Sneak Circuit Analysis of F-4C Flight Control System

D2-118545-1

F-4C

F33657-74-C-0686

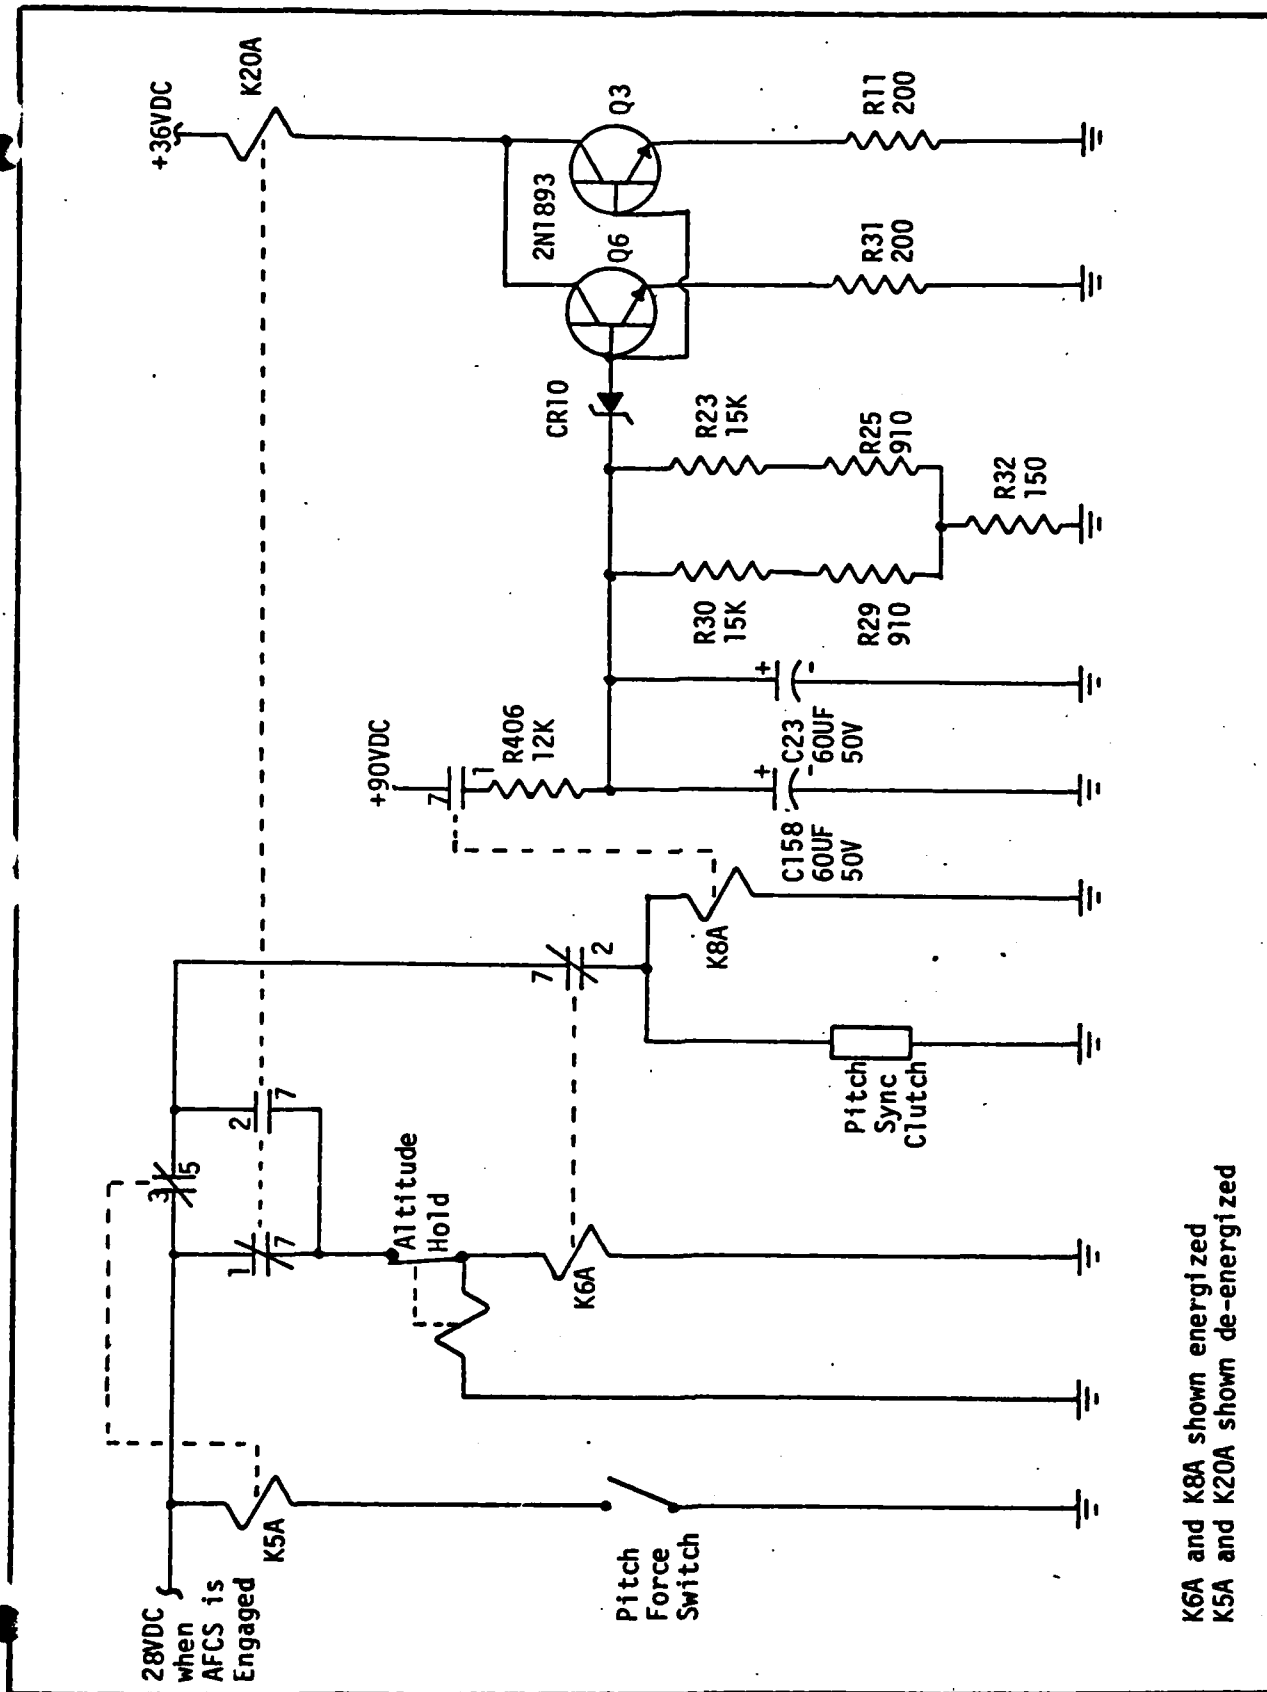
The Pitch Force Switch is closed during pilot controlled pitch maneuvers. Closing Pitch Force Switch, with Altitude Hold Engaged, energizes K5A, which opens K5A contact pins 3 and 5. This de-energizes K8A which reapplies 90 volts to the Adder Attenuator Circuitry. After C158 and C23 are charged to approximately 21 volts, a path to ground is completed for K20A. With K20A energized, K20A contact pins 2 and 7 close and contact pins 1 and 7 open. This interrupts voltage to the holding relay for the Altitude Hold Switch, which drops out.

If the Pitch Force Switch is opened before C158 and C23 have been fully charged, then K20A will not energize and Altitude Hold will remain engaged.

Control Amplifier Part #230E420G4, Ref. Des. 65-AR305

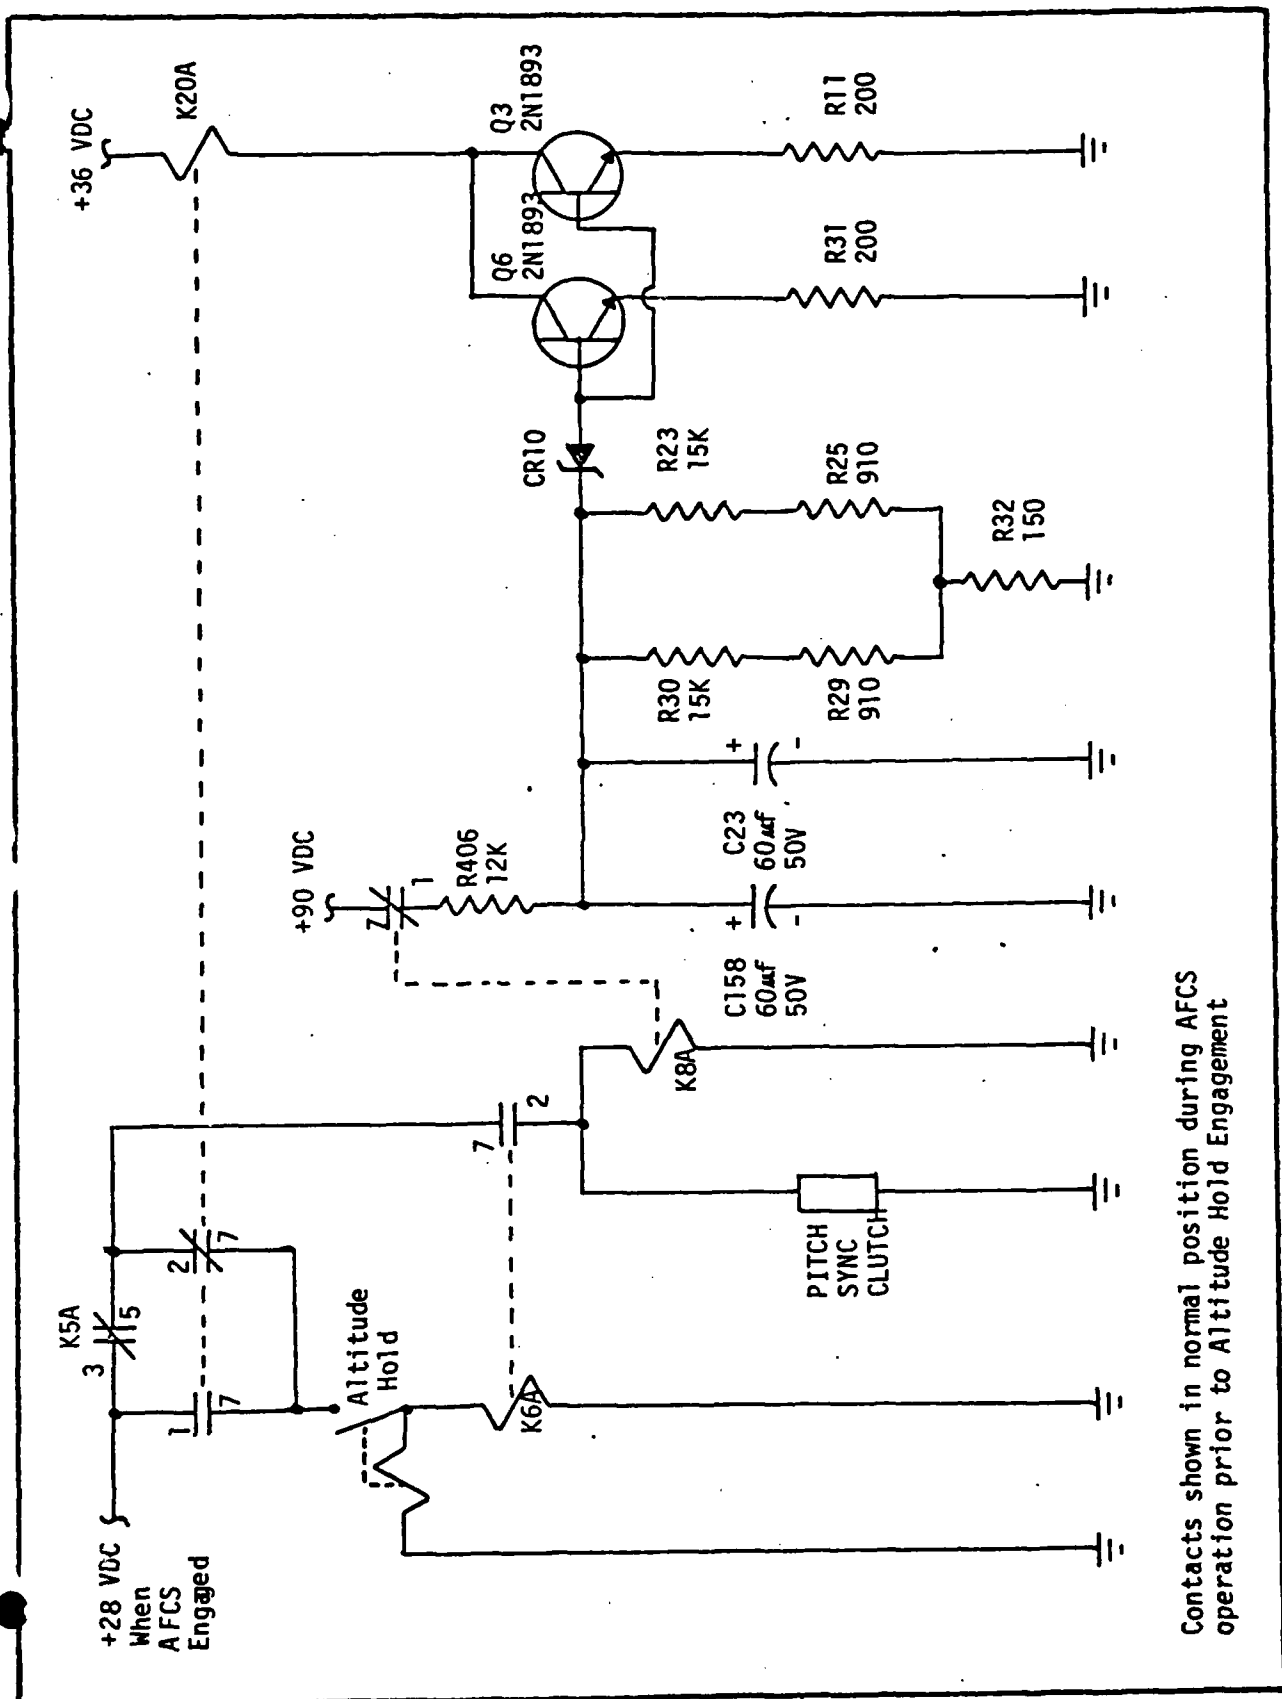
When Altitude Hold Switch is engaged, K6A energizes and closes contact Pins 2 and 7. When K8A energizes and opens contact Pins 1 and 7, thus removing the 90 VDC from the Adder Attenuator. After C158 and C23 discharge below approximately 21 volts transistor Q3 and Q6 turn off and K20A loses its path to ground and de-energizes. When K20A de-energizes K20A contact Pins 1 and 7 close and K20A contact Pins 2 and 7 open. When these contacts are switching, the Altitude Hold Engage switch loses voltage to its holding coil.

Replace relay K20A with a relay with make before break contacts.

Figure 1
STABILATOR FEEL TRIM
ACTUATOR

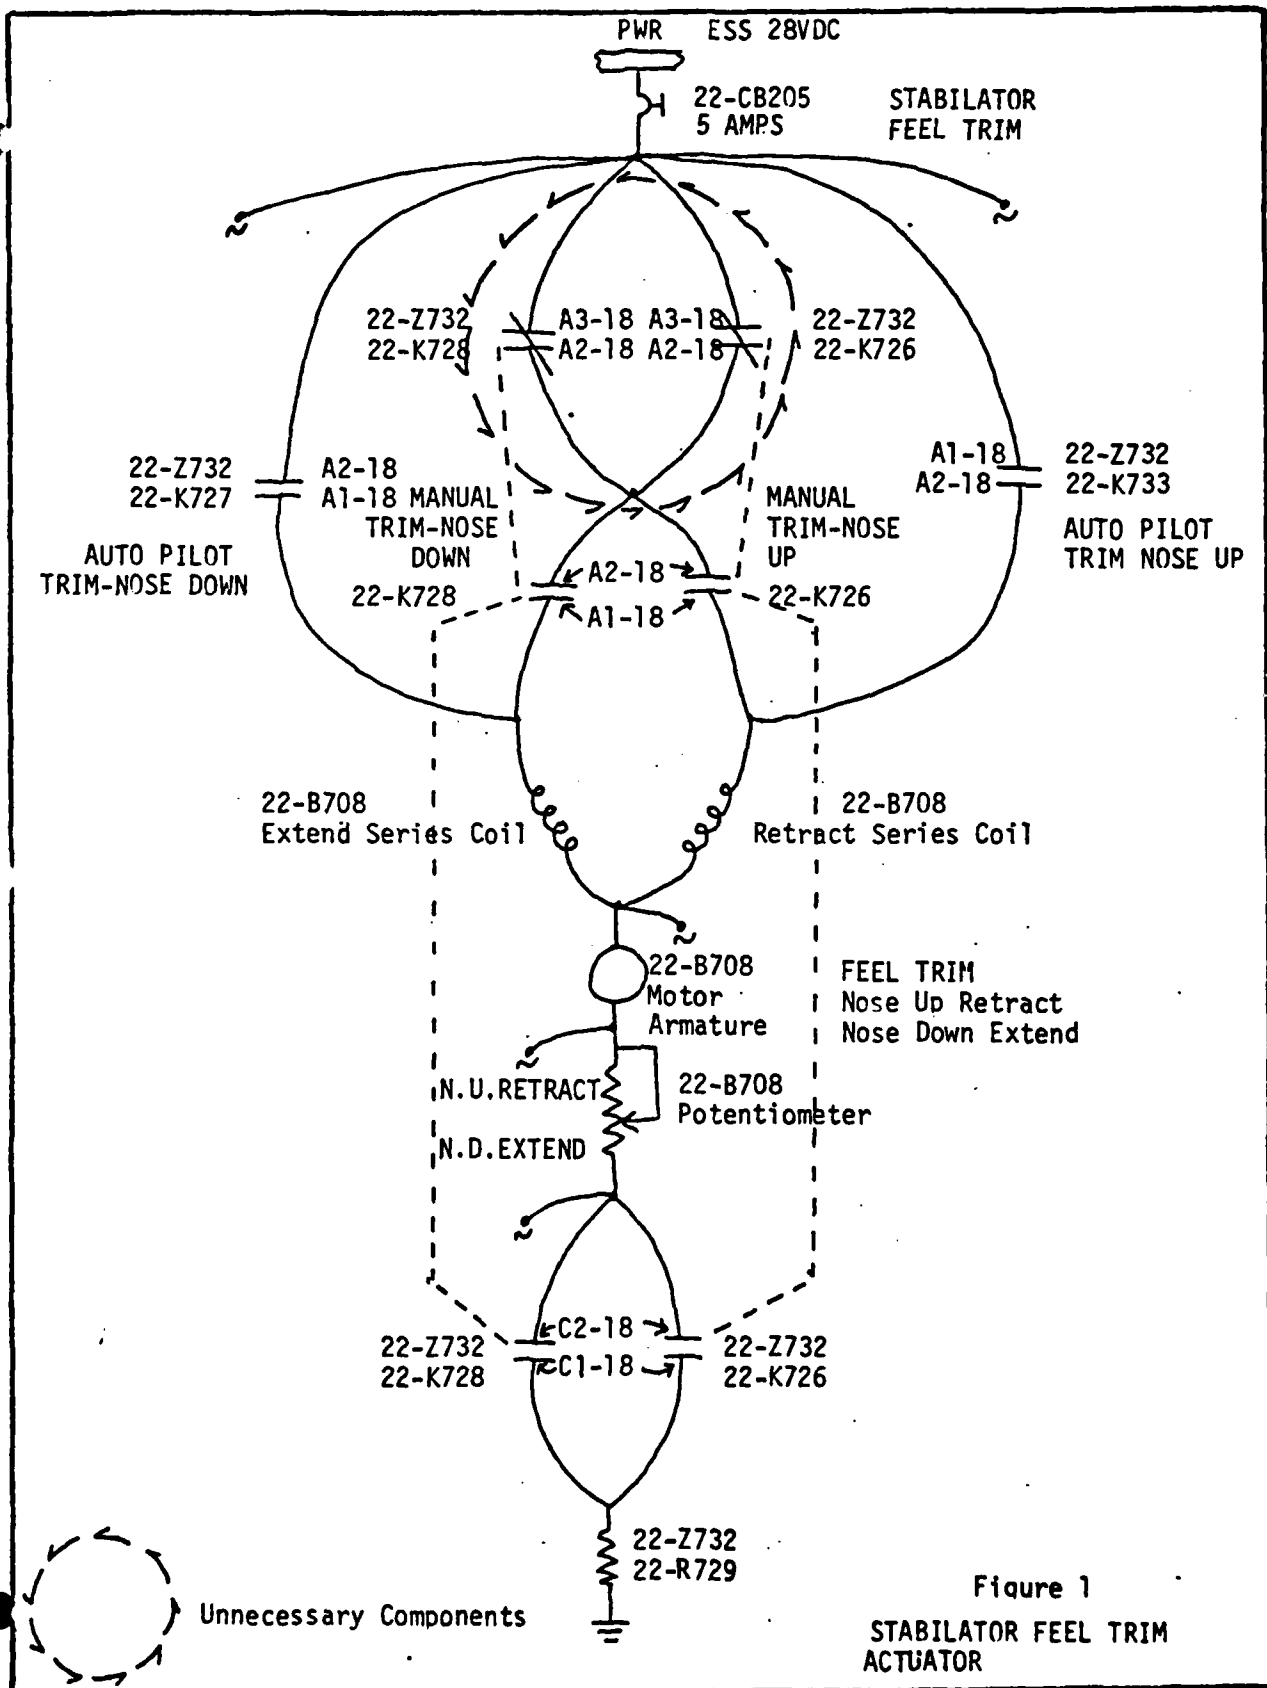
The Manual Trim-Nose Up Relay (22-K726) and the Manual Trim-Nose Down Relay (22-K728), shown in Figure 1, cannot be energized at the same time. Therefore, the normally closed contacts (A3-18/A2-18) of either 22-K726 or 22-K728 will provide continuity from Circuit Breaker 22-CB205 to the normally open contacts (A2-18/A1-18) of 22-K726 and 22-K728.

Thus, the normally closed contacts (A3-18/A2-18) of 22-K726 and 22-K728 provide unnecessary switching.

Delete the normally closed contacts (A3-18/A2-18) of 22-K726 and 22-K728 and replace them with continuity.

FIGURE 1: PITCH CANCELLOR AMPLIFIER

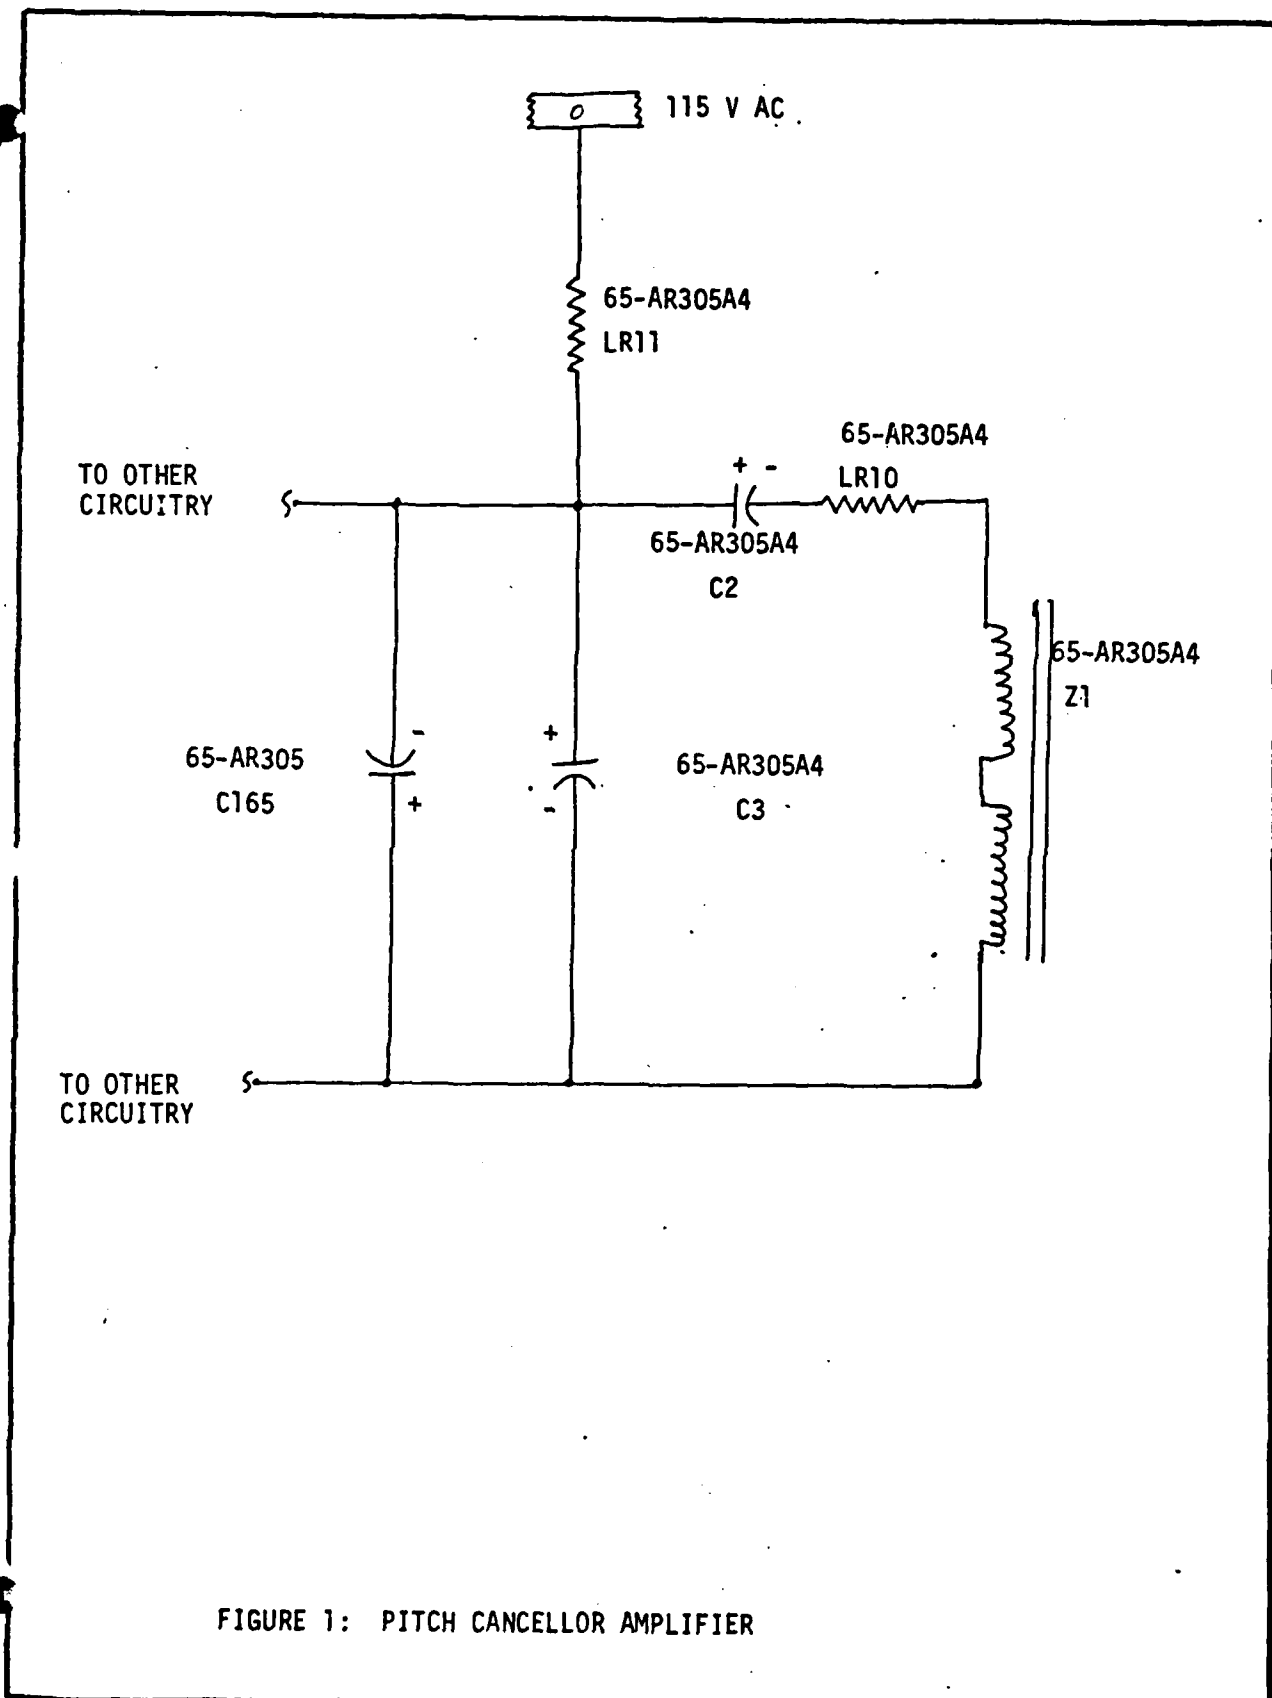
Capacitor C165 in ref. des. 65-AR305 is wired in parallel with capacitor C3 in ref. des. 65-AR305A4. The drawings in references 2 and 3 above show these capacitors wired with opposite polarity as shown in Figure 1. If these are electrolytic capacitors, one of them may burn out.

The drawings for the YAW Canceller Amplifier does not show the Capacitors in these locations with opposite polarities.

Reverse polarity of capacitor C165.

Control Amplifier, P/N 230E420G4, Ref. Des. 65-AR305

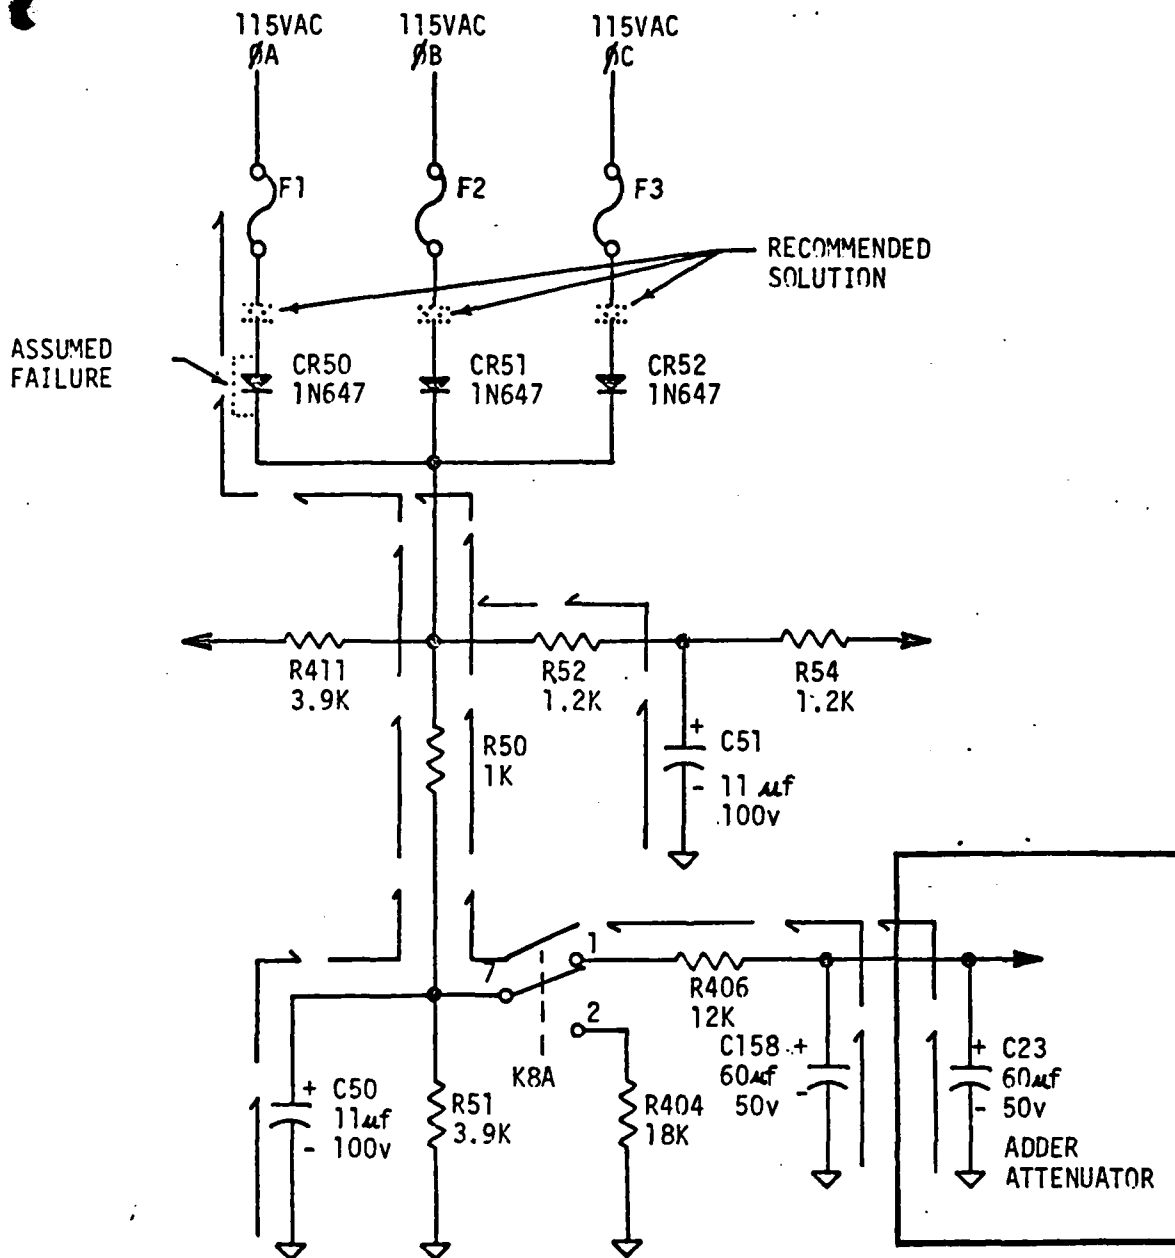
Diodes CR50, CR51 and CR52 rectify the incoming 115VAC, 400 Hz, 3 phase power to provide 135 VDC to the Adder Attenuator and Electronic Switch Monitor. This voltage is filtered by capacitors C50, C51, C158 and C23. C23 is located in the Adder Attenuator Module. The remaining capacitors are chassis mounted components. Should any of the diodes fail in the shorted mode (then fail open) each of the four capacitors will be subjected to reverse current during the negative portion of the cycle for the phase containing the shorted diode. Per reference 4 these capacitors are of the Tantalum Sintered-Slug type. Per MIL-STD-198C, Section 802, paragraph 2.1.2 these capacitors cannot withstand any reverse voltage.

Add one additional diode in series with CR50, CR51 and CR52 as shown in the attached figure.
